Engineering Review
 03/11/2021 2:18:44 PM
 dsdrice
 JeffRice@elpasoco.com
 (719) 520-7877
 EPC Planning & Community
 Development Department

PCD-ENGINEERING REVIEW COMMENTS
 IN BLUE BOXES WITH BLUE TEXT

PRELIMINARY SITE GRADING CONSTRUCTION PLANS
 FOR
SKYLINE AT LORSON RANCH

EARLY OVERLOT GRADING / EROSION CONTROL PLANS

COVER SHEET
 EARLY GRADING AND
 EROSION CONTROL PLAN

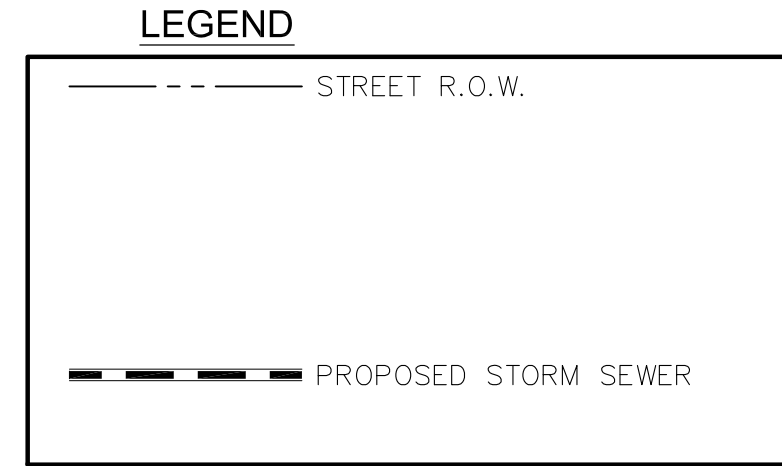
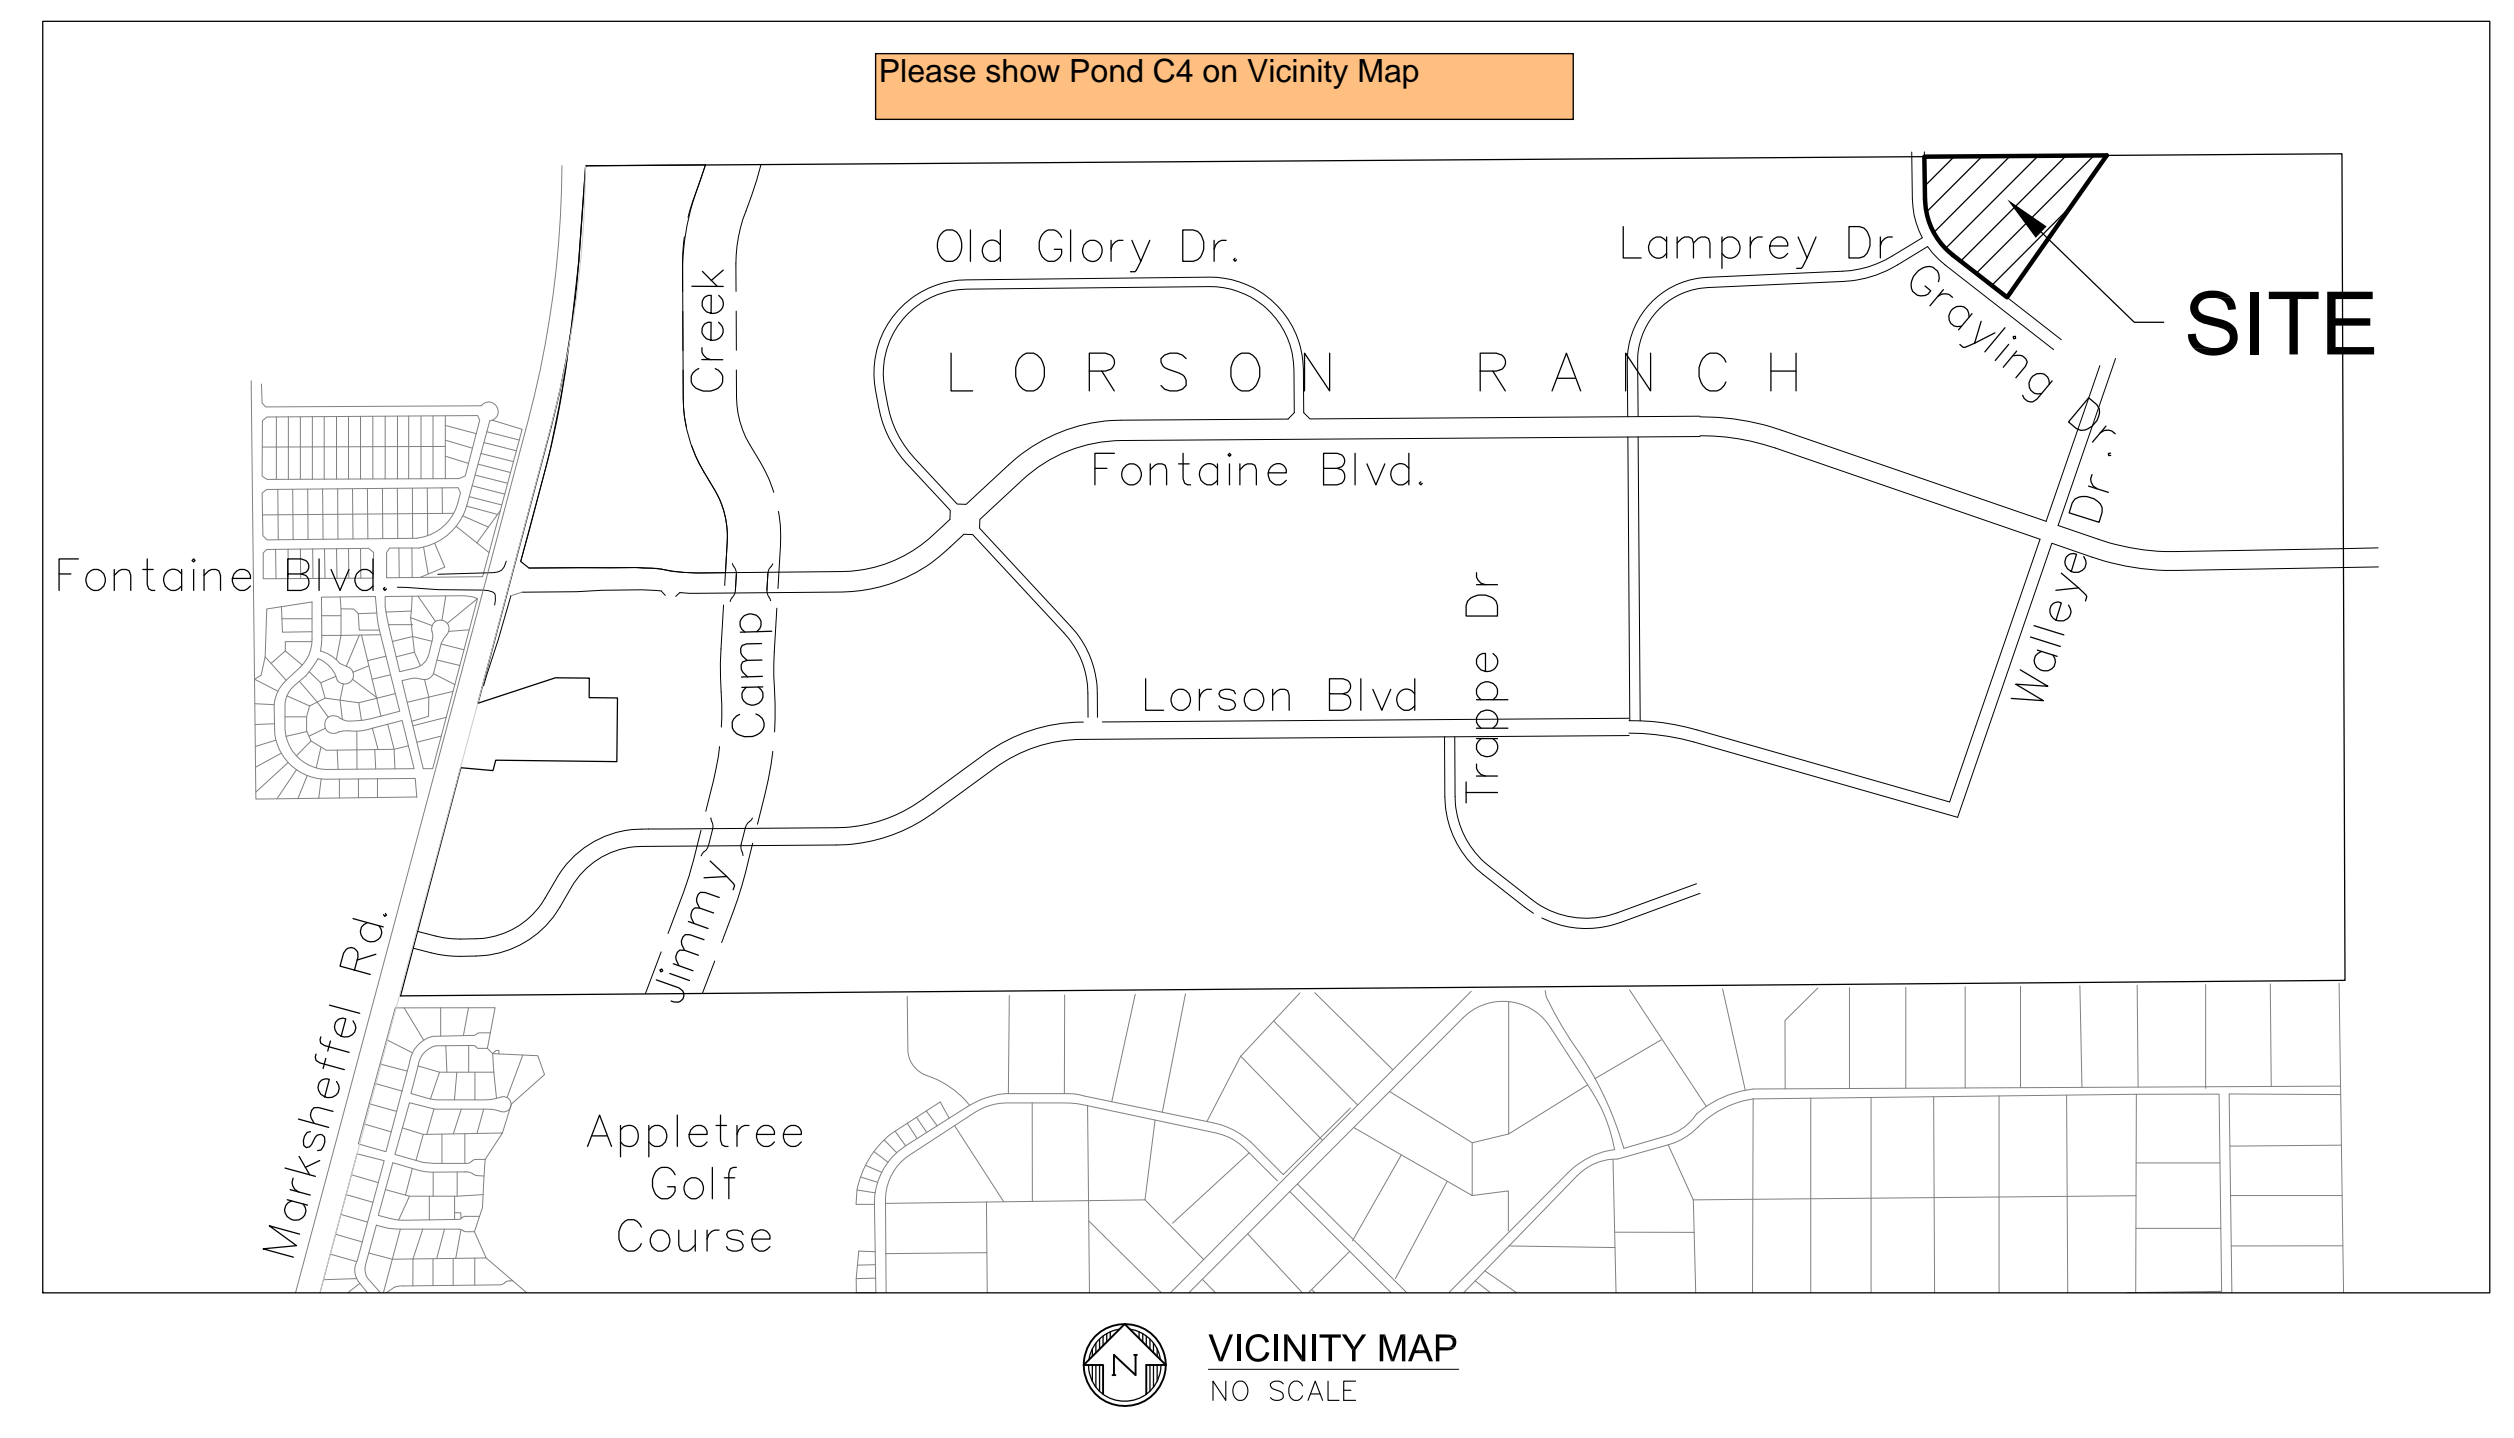
Change header to "El Paso County"

**OVERLOT EARLY
SITE GRADING
TYPICAL ROADWAY SECTIONS**

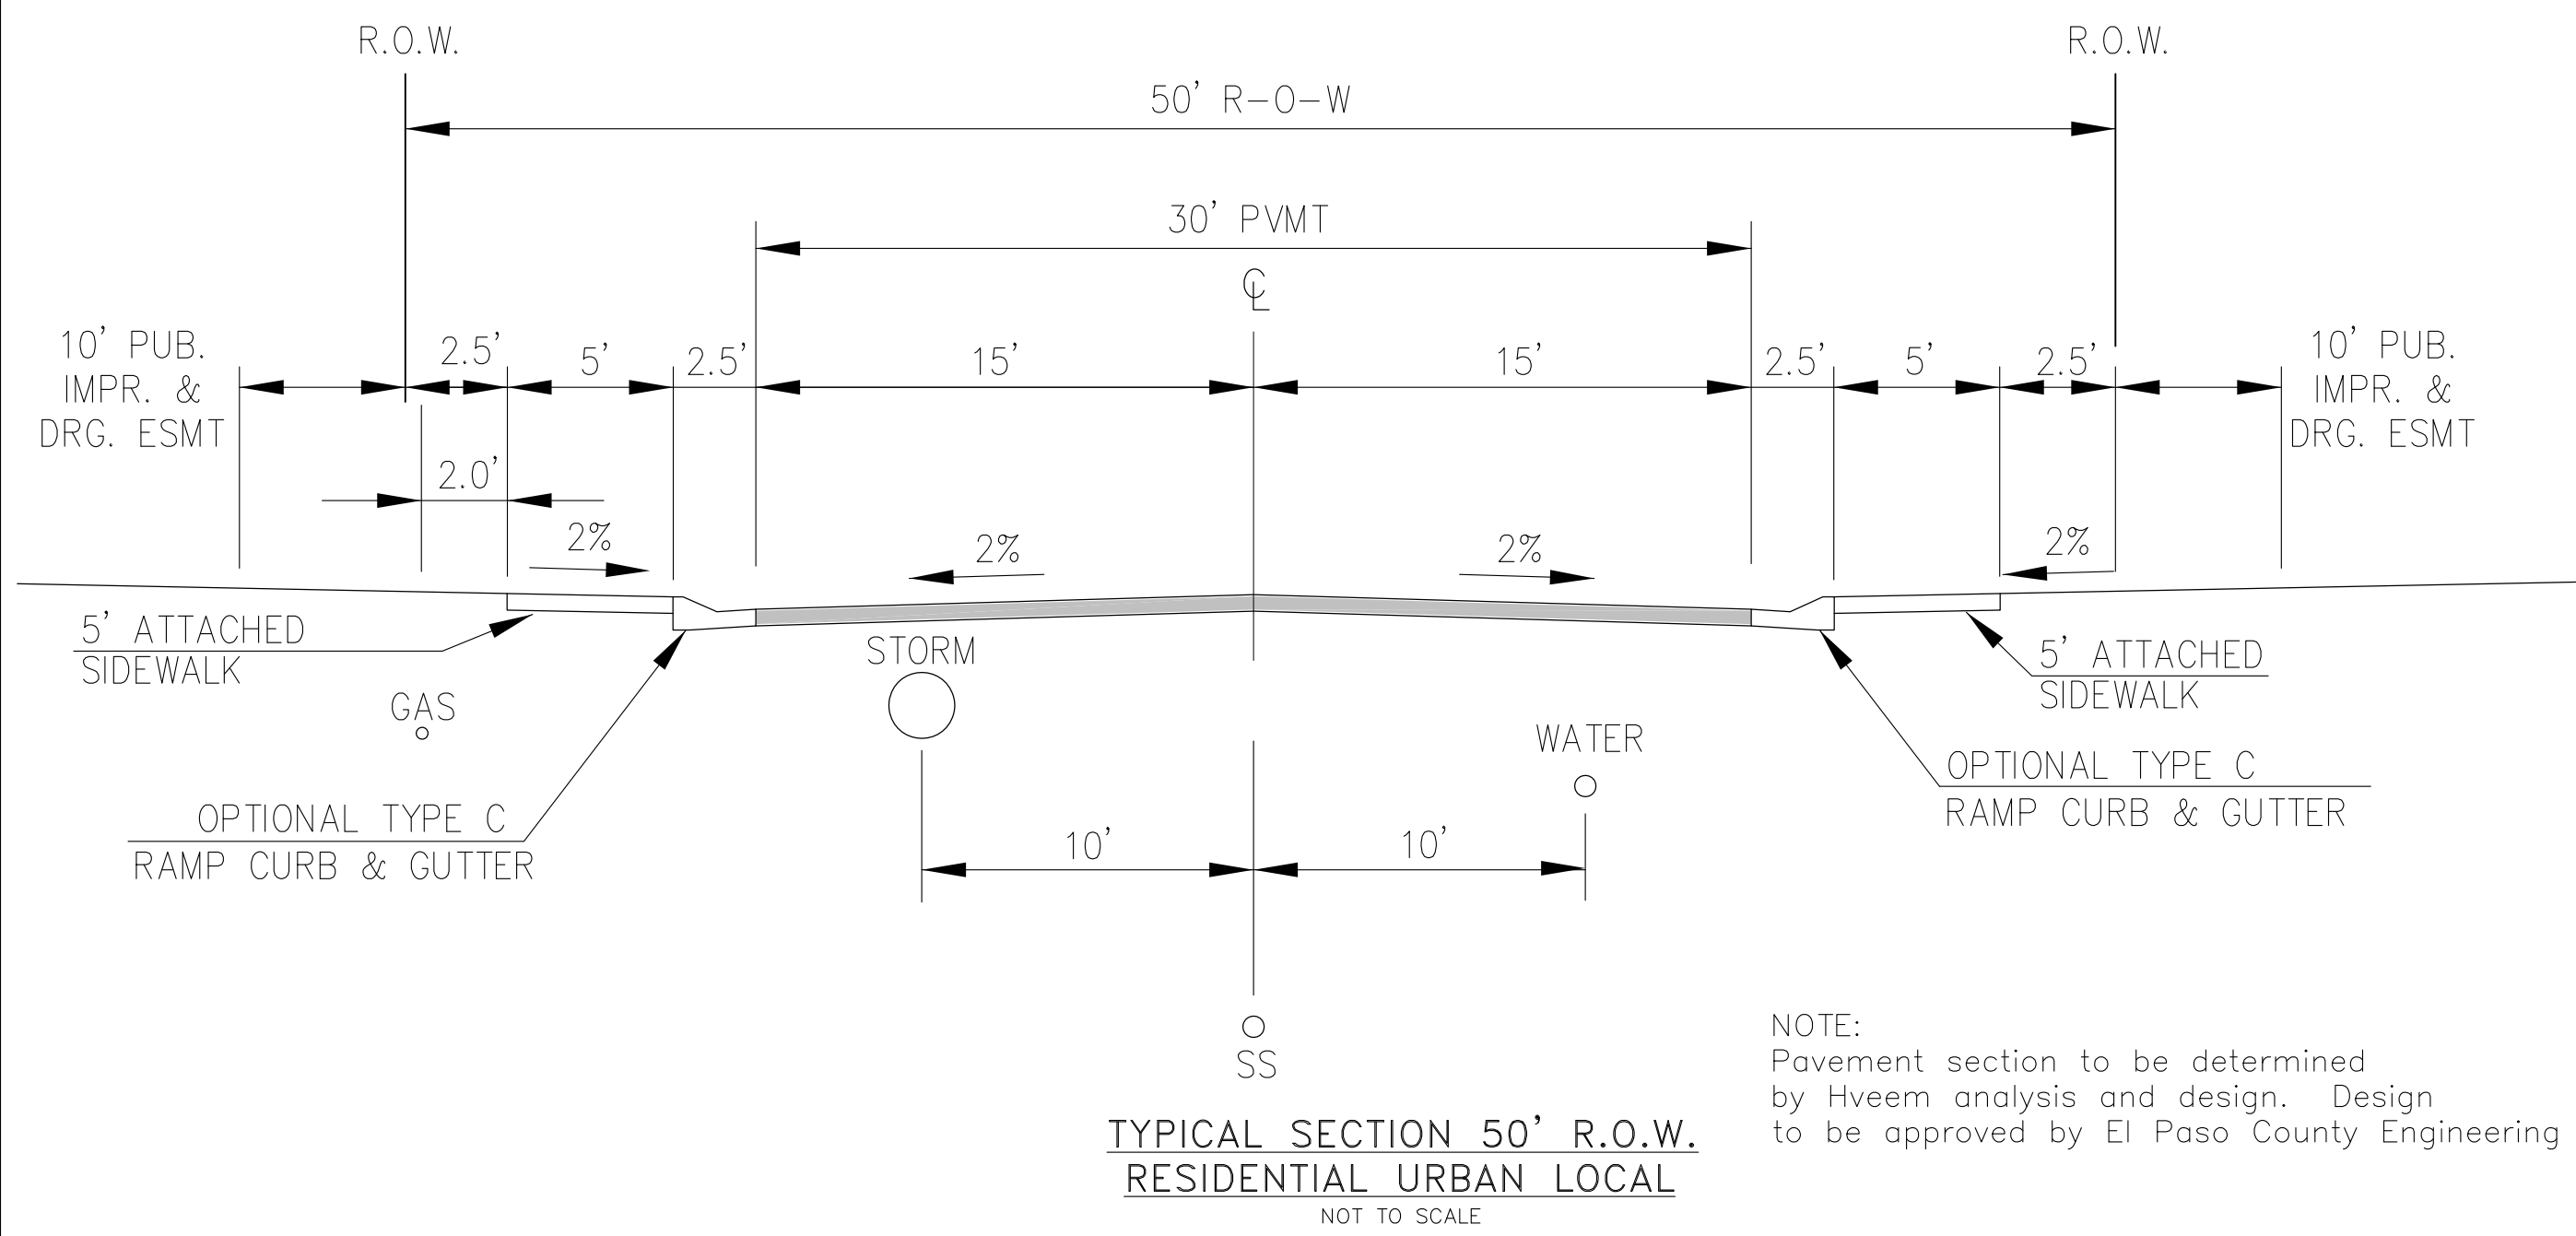
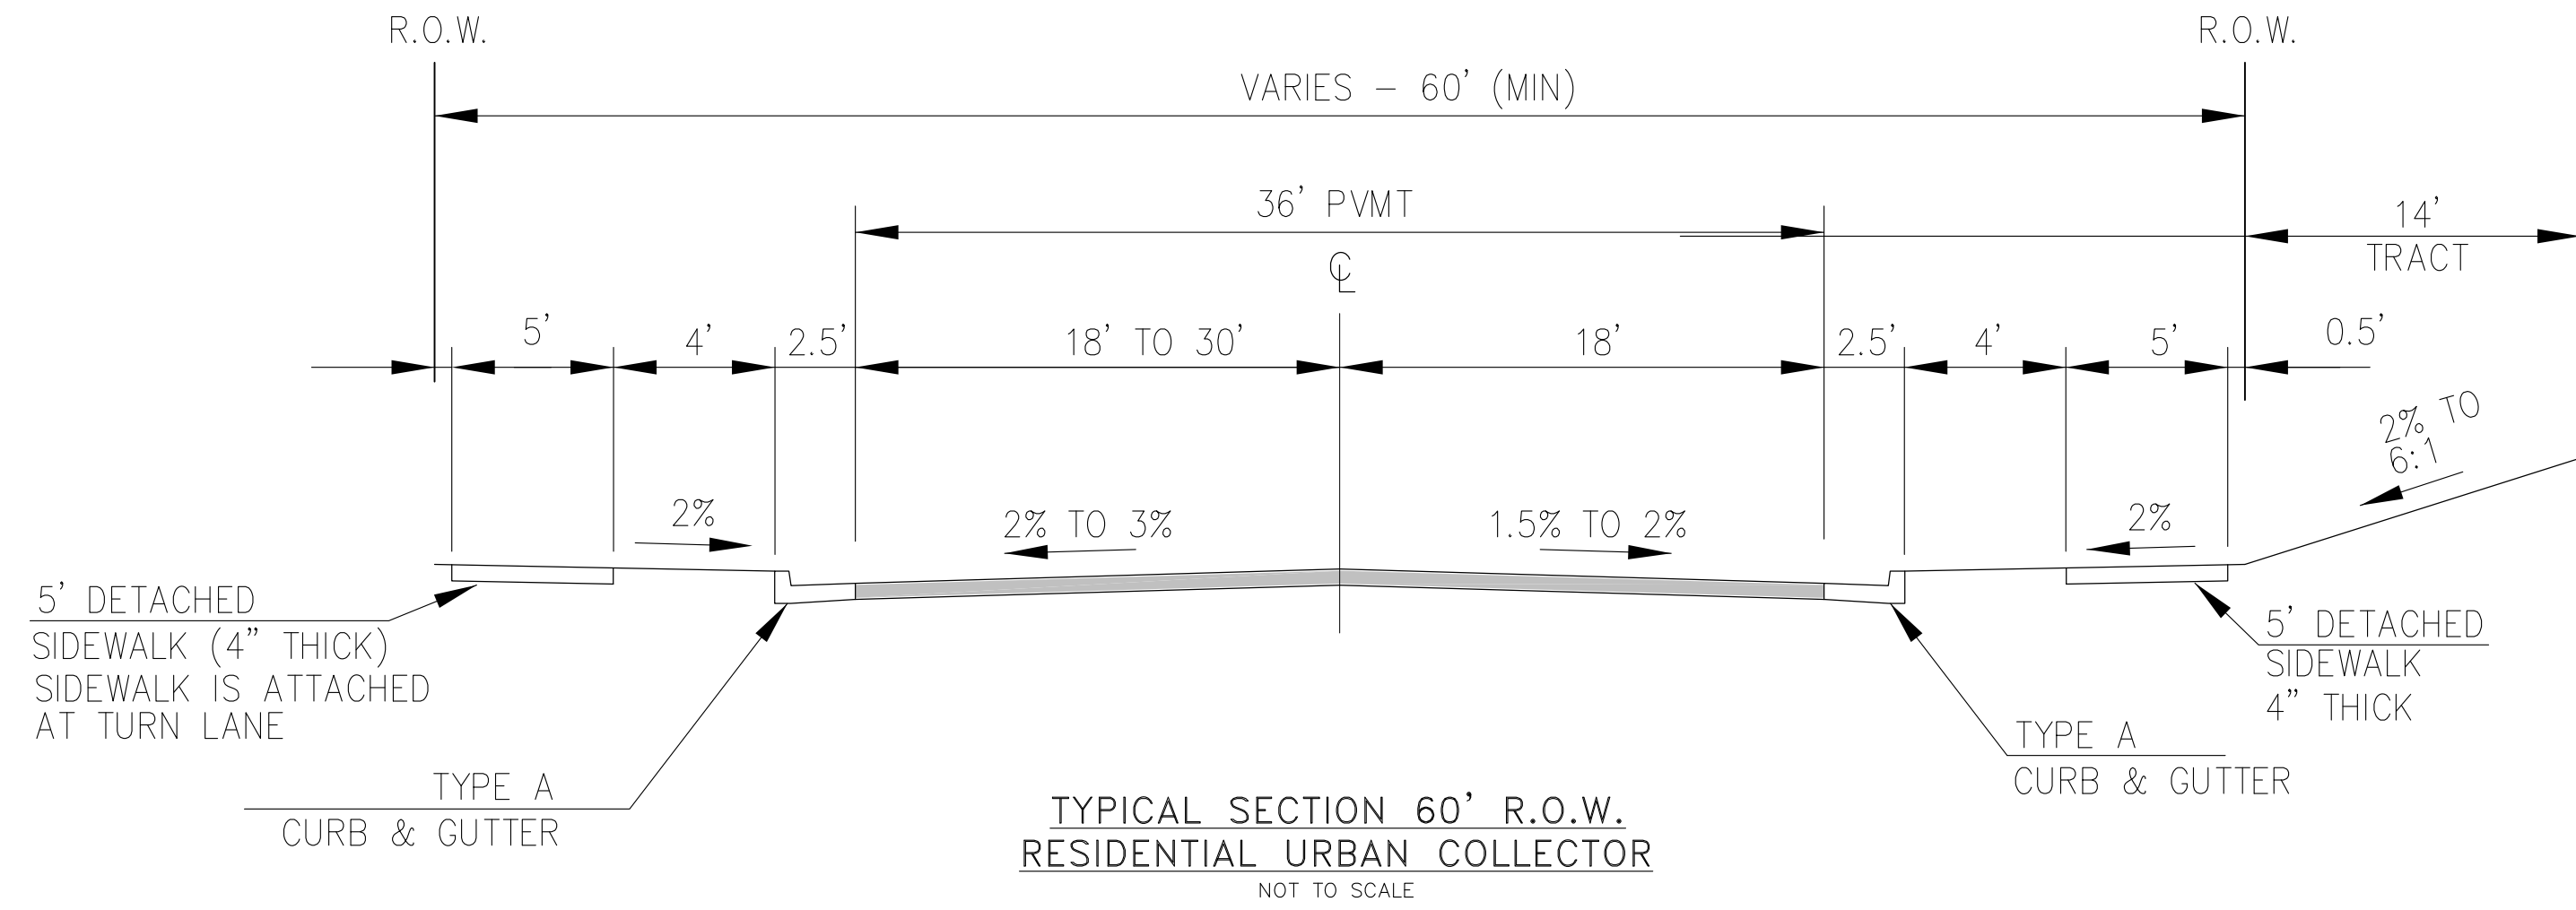
for early grading, do not show asphalt or concrete sidewalks on road detail
